Preliminary/Final Drainage Report

# Meadowbrook Park El Paso County, Colorado

PCD File No.: PUDSP208

Prepared: March 18th, 2021  
Revision 1: June 2, 2021

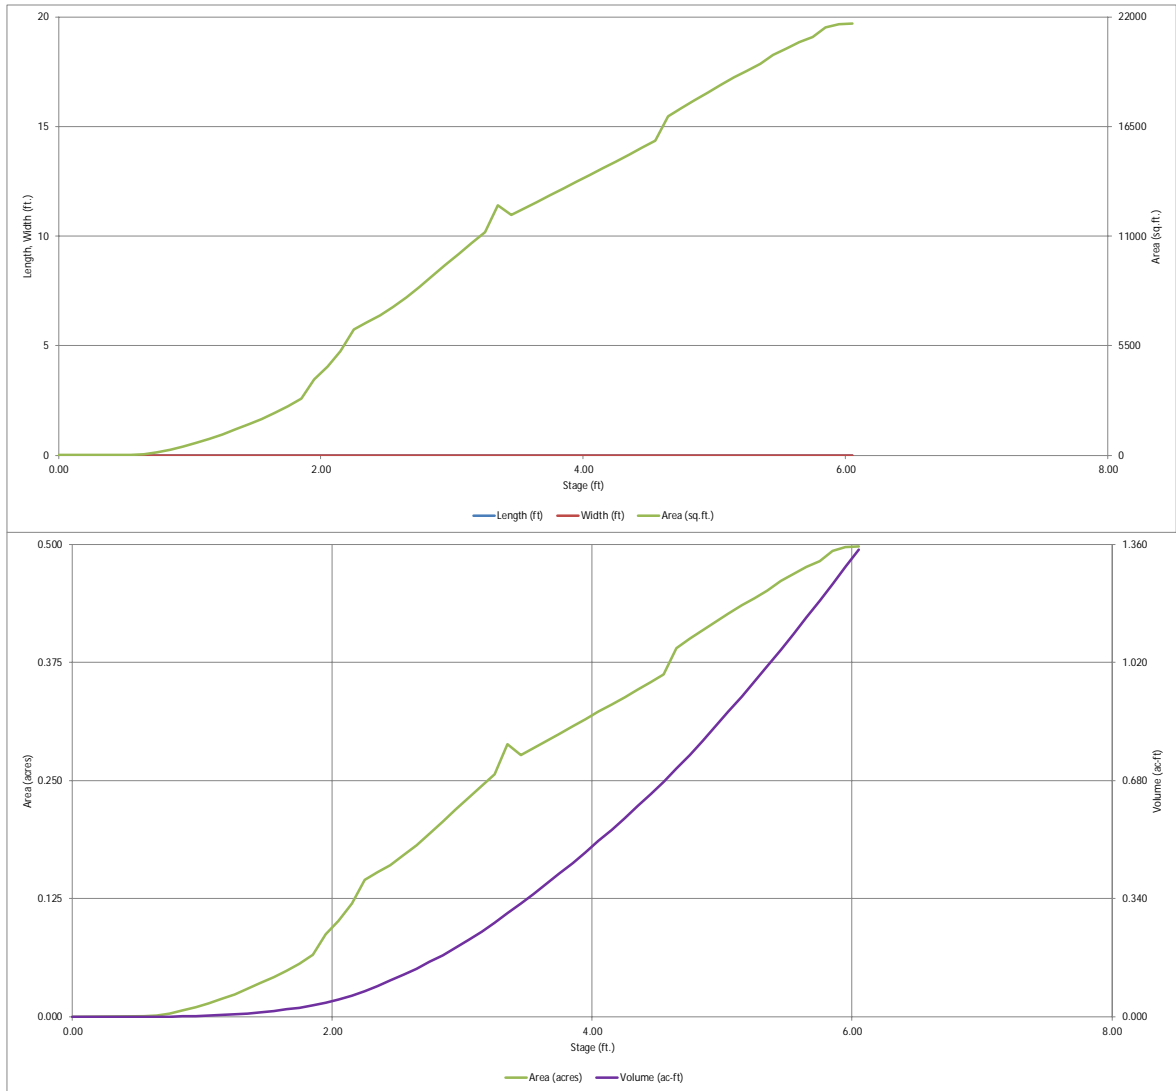
Please identify the specific riprap size and provide the supporting calculations.

# DETENTION BASIN OUTLET STRUCTURE DESIGN

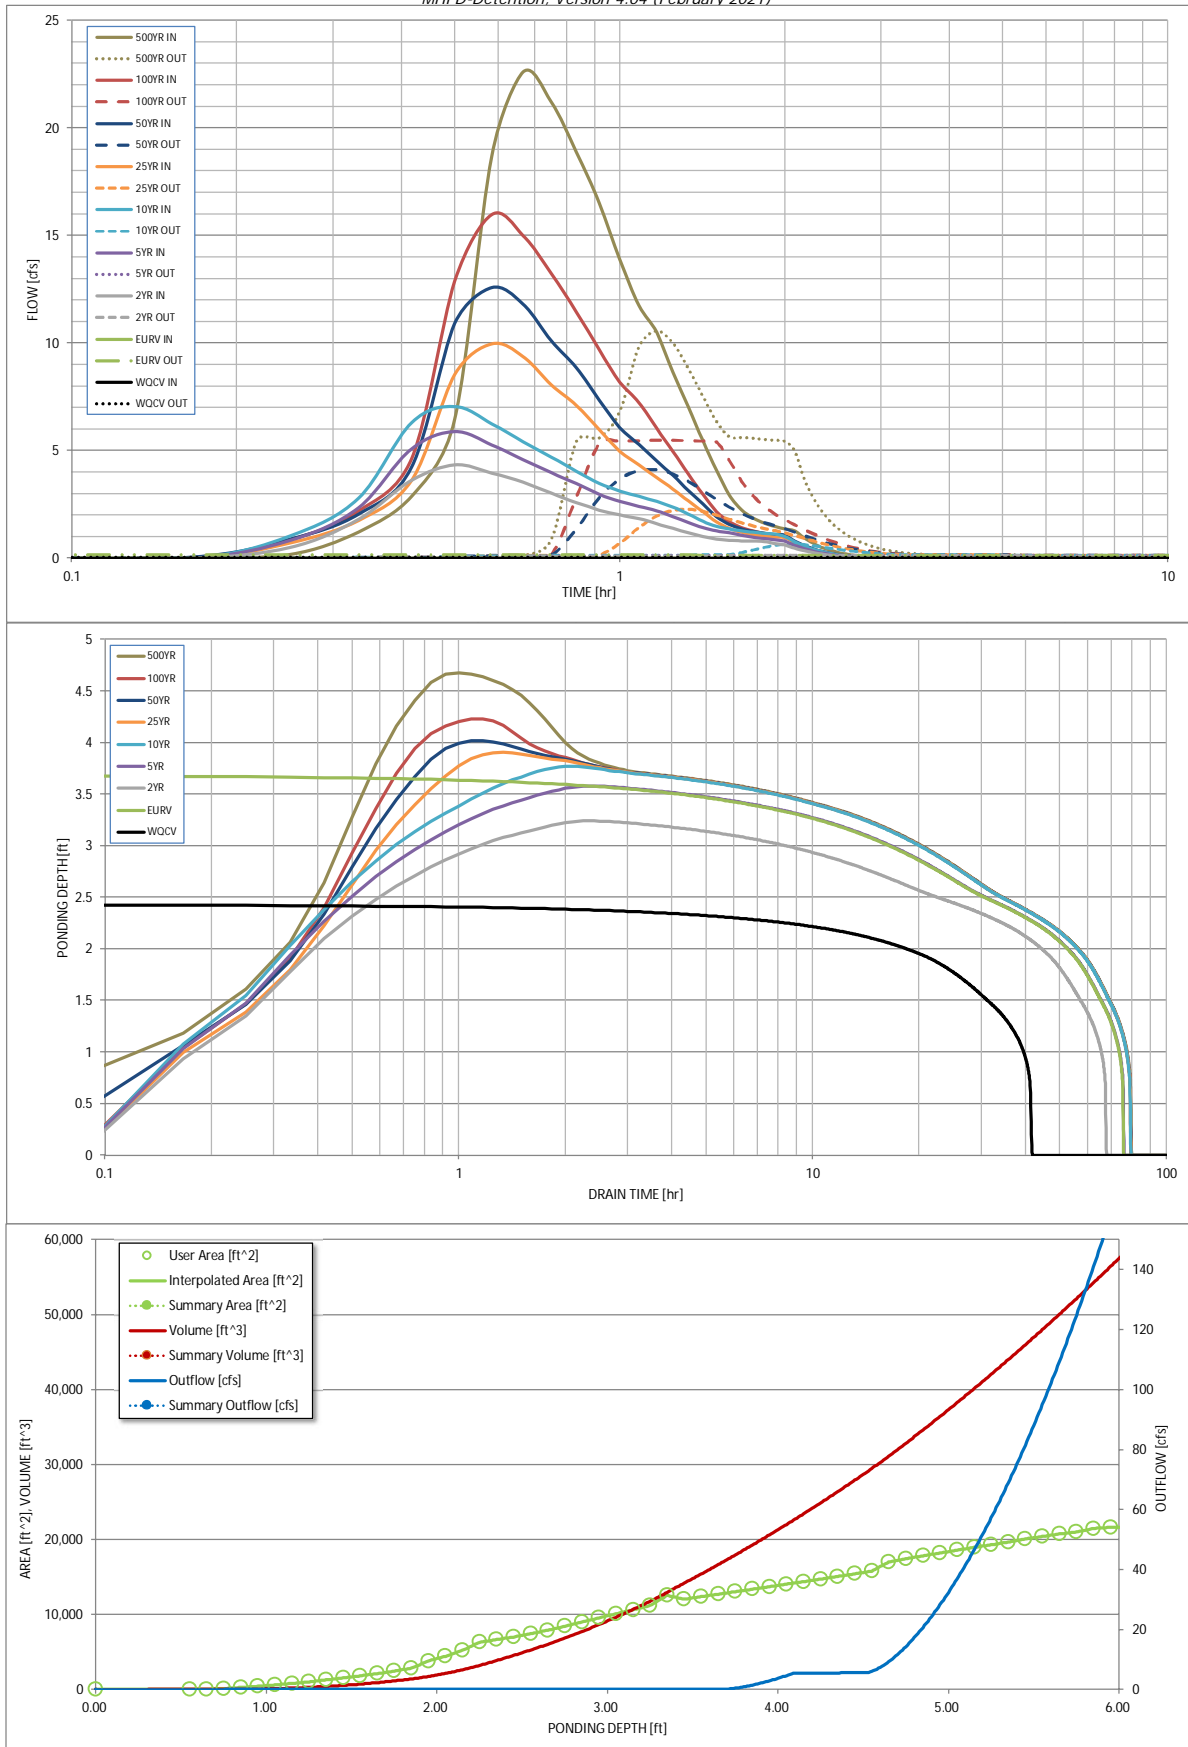
Can this be revised so that the released flow is equal to or less than pre-development?
